**Doc. No. SSE/6/a**  
**Case Ref. 2032278**

Appeal by BAA Ltd and Stansted Airport Ltd following the refusal by Uttlesford District Council of planning application UTT/0717/06/FUL

## **Proof of Evidence on behalf of Stop Stansted Expansion**

### **Air Noise Issues**

Figure 1: Growth rate of ATMs vs 57 dBA Leq land area

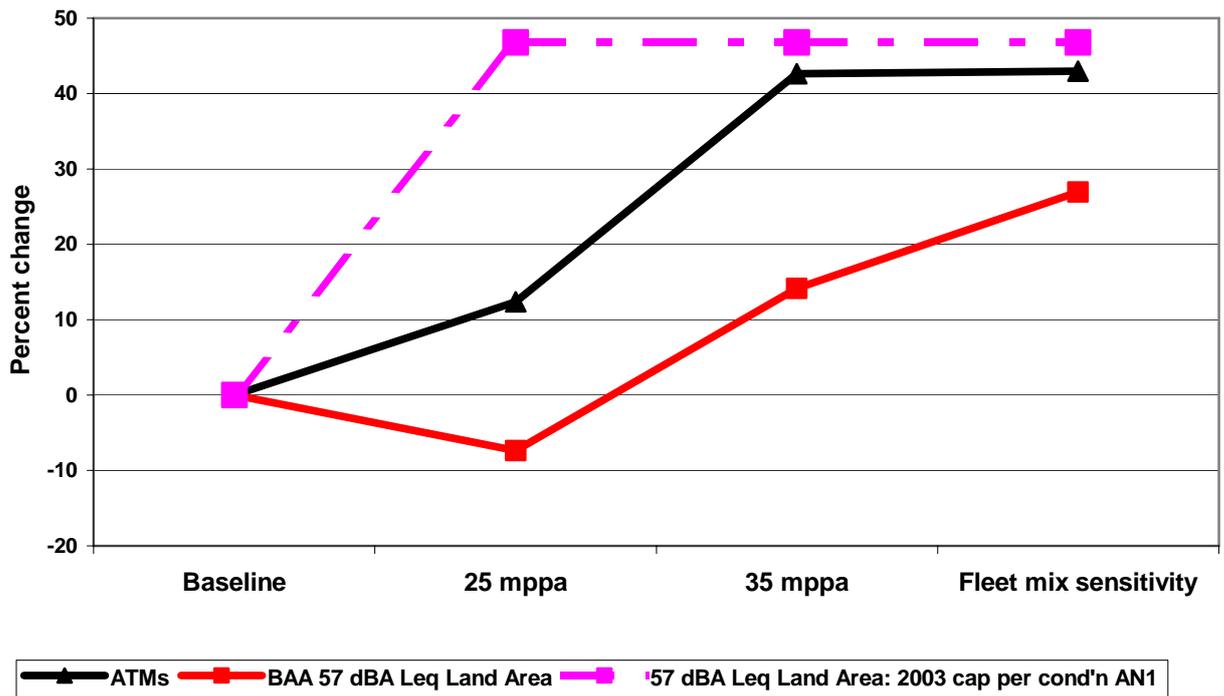
Annex 2 shows that the relationships between the 57 dBA Leq land area and ATMs and numbers of passengers can sometimes alter counter-intuitively. Indeed they can vary markedly even to the extent of moving in opposite directions and the Table shows clearly that the 43.6 sq km land area cap was a gross over-provision.

**Figure 2: Map showing origin of complaints made to Stansted Airport's Flight Evaluation Unit compared with extent of Department for Transport's official 'noise annoyance area'**

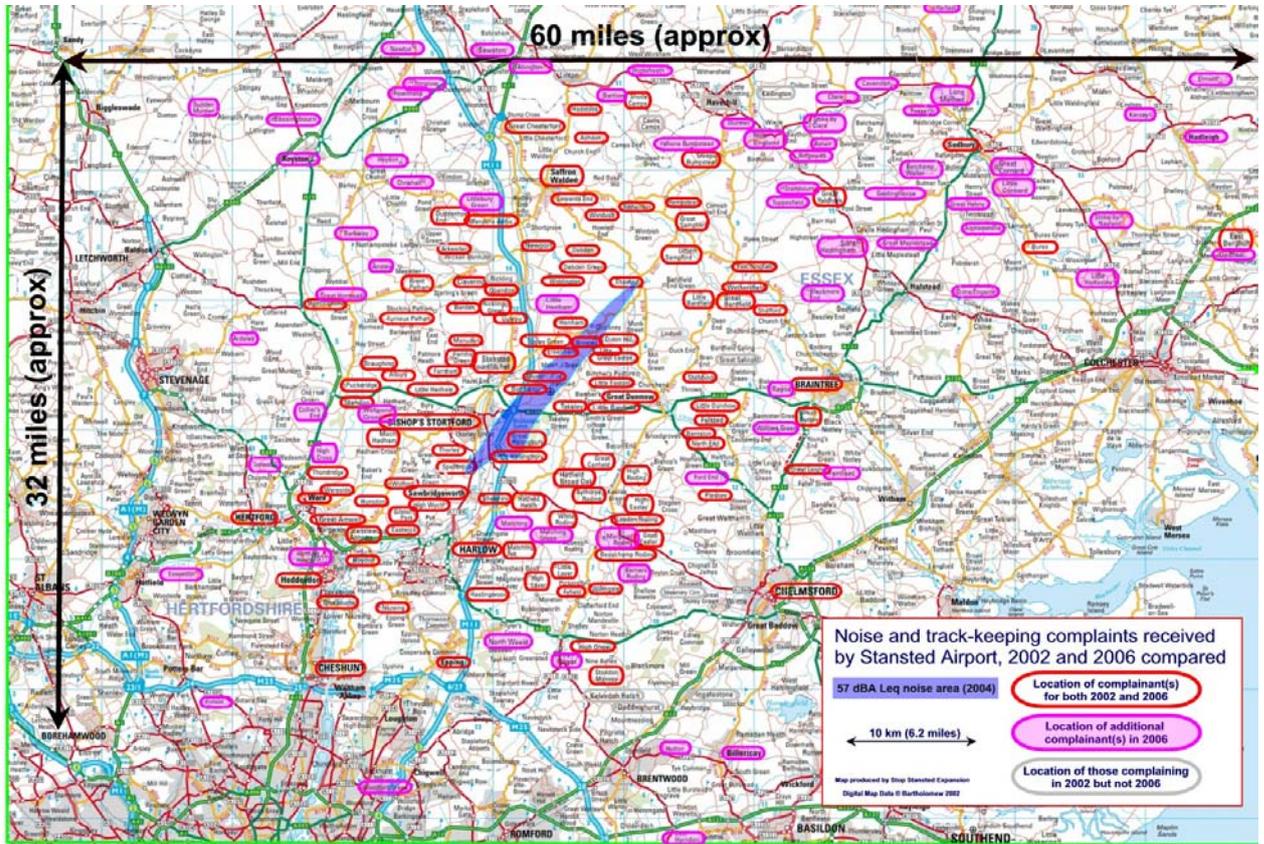
- 3.4.7 A further illustration of the inappropriateness of the 57 dBA Leq contour as an annoyance indicator may be obtained from the illustration in Annex 1 which shows the enormous disparity between the official 'noise annoyance' of 57 DBA Leq (the area in blue) and the much larger area from which complaints were made about Stansted aircraft noise.

Figure 2 illustrates that the 'official' area of annoyance (i.e. the 57 dBA Leq area, in blue) bears scant relationship to the huge area where residents are actually complaining about aircraft noise; and even although this 57 dBA Leq area has shrunk in recent years, the areas where complaints originate from have grown considerably between 2002 and 2006 particularly to the north-east of the airport.

**Figure 3: Decoupling of ATMs and 57 dBA Leq land area trends, illustrating excess headroom in '2003 Permission' land area cap**  
 Source: ERCD report 0603 with line indicating 2003 permission land area cap added by SSE

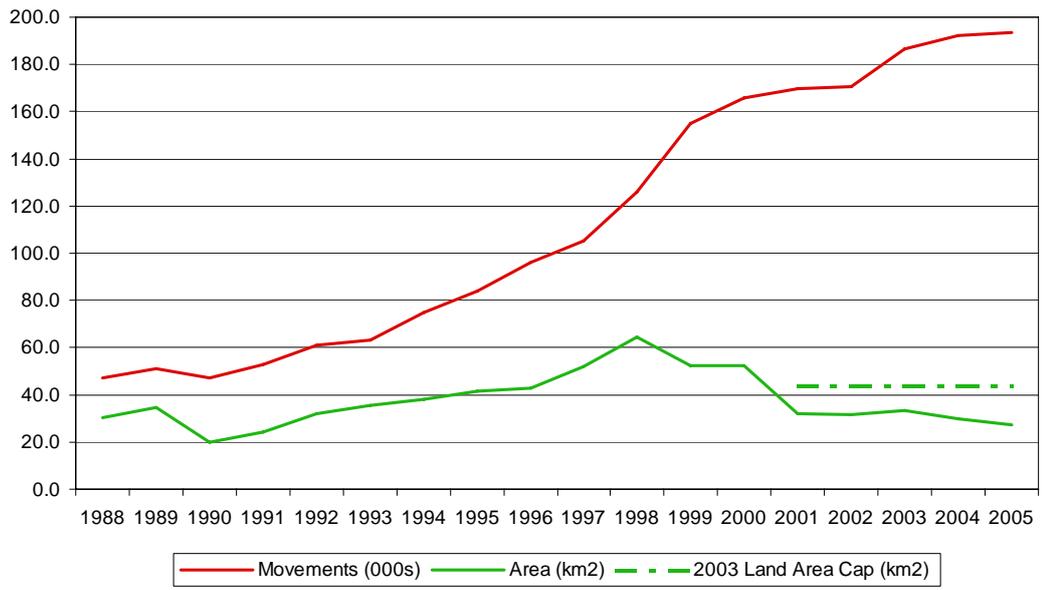
It can be seen from the first section of Table A2.1 on the following page that the envisaged increase in Leq land area was a gross overprovision: an increase of 36.7% in the Leq contour land area being allowed to provide for an increase of 49.4% in total air traffic movements (ATMs). Subsequent events have confirmed this overprovision, as shown by the second section of the table which demonstrates that in the ensuing two years,<sup>23</sup> although the ATMs have increased by over 17%, the Leq land area has actually reduced by nearly 14%.

This historical reality depicted in the second section of the table contrasts vividly with the contents of the bottom section of the table, which show what is implicitly planned by BAA in the current application.<sup>24</sup> The bottom section of the table shows that BAA's demands would represent an increase in the 57 dBA Leq land area (when measured from 2005) at a faster rate than the rate of increase in ATMs (58.5% increase in 57 Leq land area compared to 42% increase in ATMs). This represents an even bigger percentage increase for the Leq land area than in the grossly over-provisioned 2003 condition.
